# Service Bulletin

Bulletin No.: 19-NA-277

**Subject: Poor Fuel Transfer and/or Rear Fuel Tank Collapsed, DTCs P2635, P2636, P2A00 and/or P026D Set**

5397974

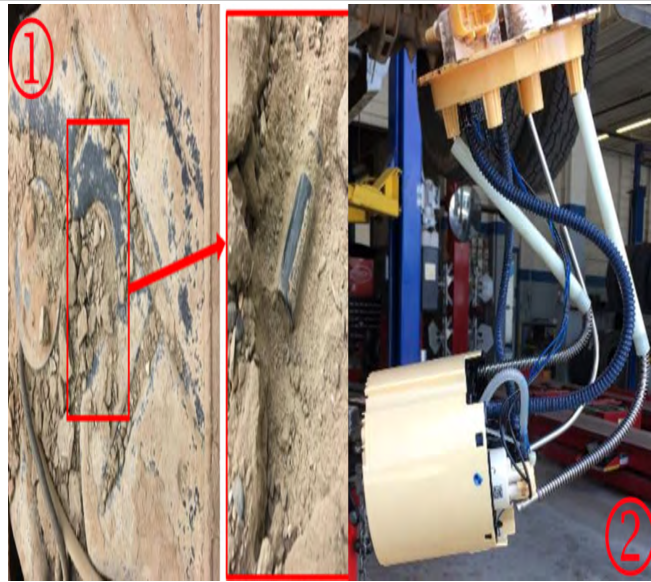
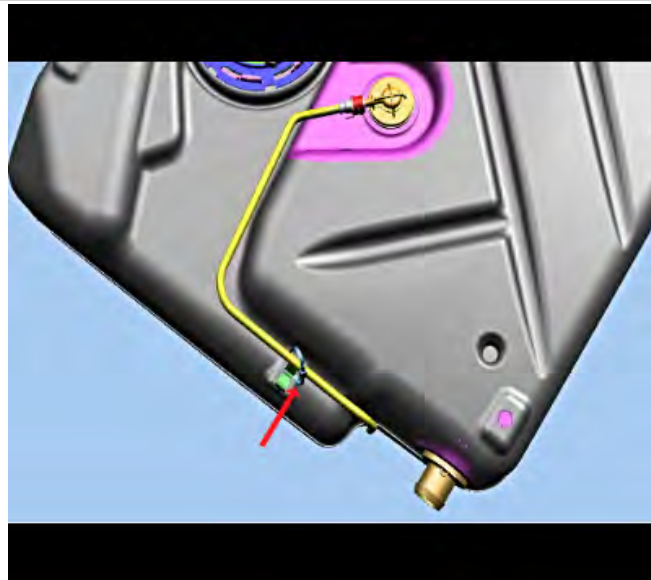
This condition may be caused by dirt and/or debris collecting on the top of the rear tank (1), plugging the vent causing the sending unit to draw air and bend the fuel tank fuel pump (2), as shown in the picture above.
